# Attachment B2

**Re: *Wind Tunnel Modeling Evaluation for the Mirant Potomac River Generating Station – Final Report***

On behalf of the City of Alexandria, we have reviewed the Mirant Potomac River, LLC's Wind Tunnel Modeling Evaluation for the Mirant Potomac River Generating Station, Final Report ("Wind Tunnel Study"), dated August, 29, 2006 and prepared by CPP, Inc. Our review reveals several erroneous assumptions from which the equivalent building dimensions ("EBDs") were derived. Since the use of these dimensions will lead to higher output rates for the Potomac River Generating Station ("PRGS") under the EPA's Administrative Compliance Order by Consent ("ACO"),<sup>1</sup> you should withhold approval of the Wind Tunnel Study and use of the EBDs set out therein pending a full review and resolution of the issues we raise in this letter. Specifically, we identify the areas where the Wind Tunnel Study simulations will need to be refined to more accurately characterize the actual airflow around the PRGS. Some of these areas relate to the scope of the study, while others address the inaccurate assumptions related to the model inputs.

Figure 1 - View from Marina Towers Facing South-Southwest.

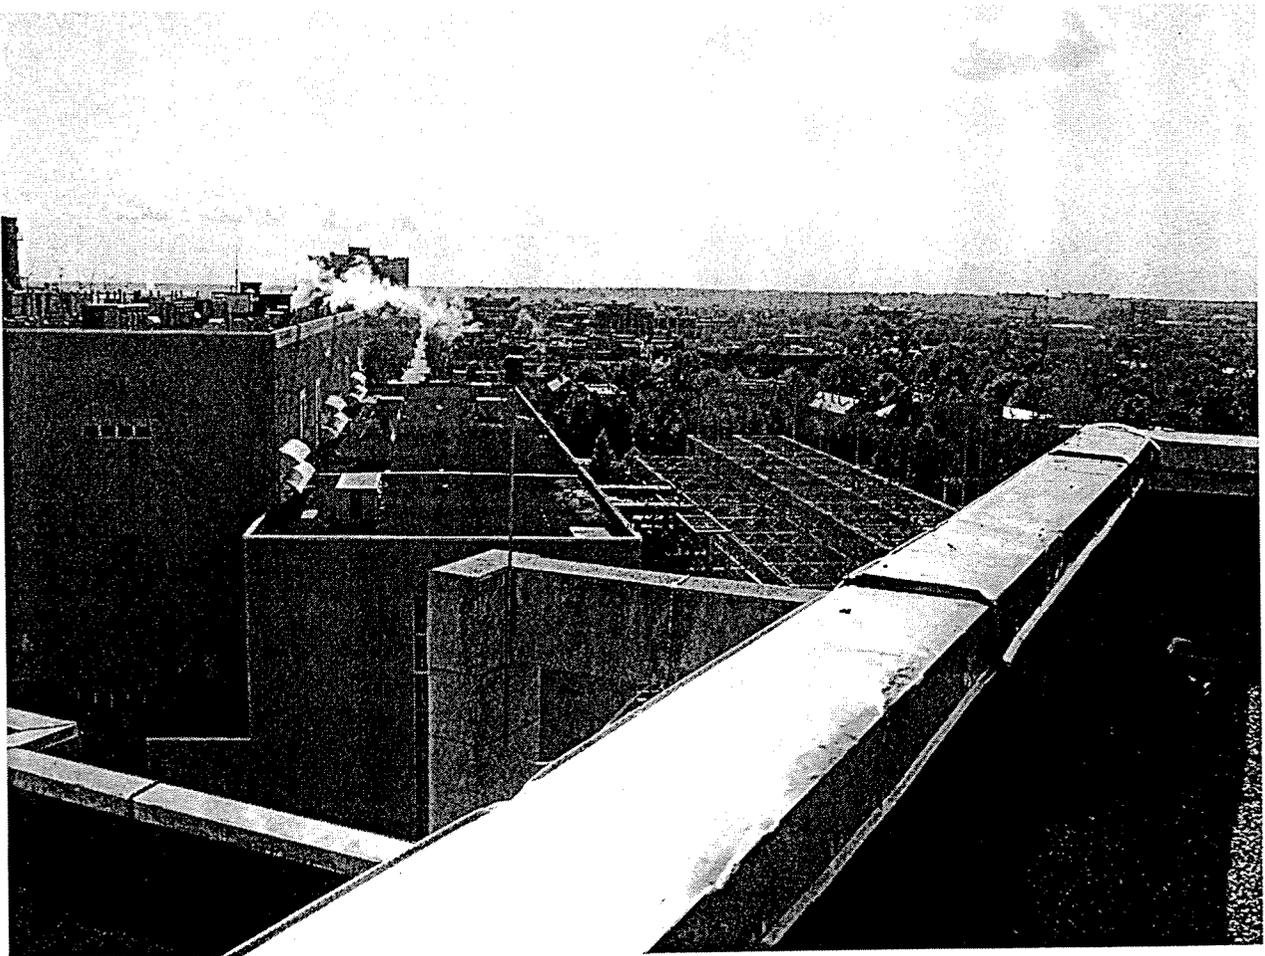
The most critical sector for flow from Mirant towards Marina Towers is 155<sup>0</sup> through 175<sup>0</sup>. Land trajectories with fetch of approximately 750 m or more start at 159<sup>0</sup>. On this basis, over water trajectories would only be applicable to 25 percent of the sector of concern, *i.e.* 155 through 158<sup>0</sup>. The Wind Tunnel Study has incorrectly assumed over-water trajectories through 170 degrees. According to the AERMET user's guide (Page 5-9) for trajectories with surface roughness values in the range of 0.5 to 1.5m, land influences up to 100m would occur by 700 m of fetch. Applying the same slope factor to the actual stack top would show a distance of approximate 335 m to equilibrate to overland conditions. Applying a methodology from Panofsky & Dutton (1984) shows the estimated height of the interface change as a function of fetch produced, an estimate of 285m. The wind tunnel results are based, therefore, on a much smoother surface than is actually encountered. Figure 1, taken at the roof of Marina Towers facing south-southwest, and Figure 2 show the view from the overland fetches that actually influence the transport and dispersion conditions upwind of key trajectories from Mirant towards Marina Towers. Tree cover and multi-level structures are encountered along the overland fetches. There is no technical justification for using such a smooth, *i.e.*, 15 cm, surface roughness value within the overland range of 159<sup>0</sup> through 175<sup>0</sup> – and beyond on a clockwise basis. The wind tunnel analysis, therefore, should assume overland fetches from 159<sup>0</sup> and onward on a clockwise basis.

The primary objective of any air quality analysis is to represent site-specific conditions as accurately as possible, as is stated in the EPA Guideline on Air Quality Models. The trajectories from the Mirant facility towards Marina Towers are very unusual in that the closest stack height (48m) and the nearby highrise, Marina Towers (43m) are only approximately 105 m apart. The potential for severe plume impaction is pronounced. It is very important, therefore, that the rate of dispersion be defined as accurately as possible, especially for the most critical trajectories. The primary concern is that by defining most of the critical wind flows as over-water flow, with very smooth surfaces, the rate of dispersion is reduced. The affect that this understatement will have on the analysis needs to be determined once the other issues noted in this review are resolved, because the present approach has a high potential to significantly understate maximum impacts at Marina Towers.

- (v) Mirant should perform all resimulations in the wind tunnel analysis by correcting the treatment to overland trajectories starting from 159 degrees and onward on a clockwise basis. Dispersion modeling also should be consistent with actual surface conditions along this critical trajectory, and all trajectories.
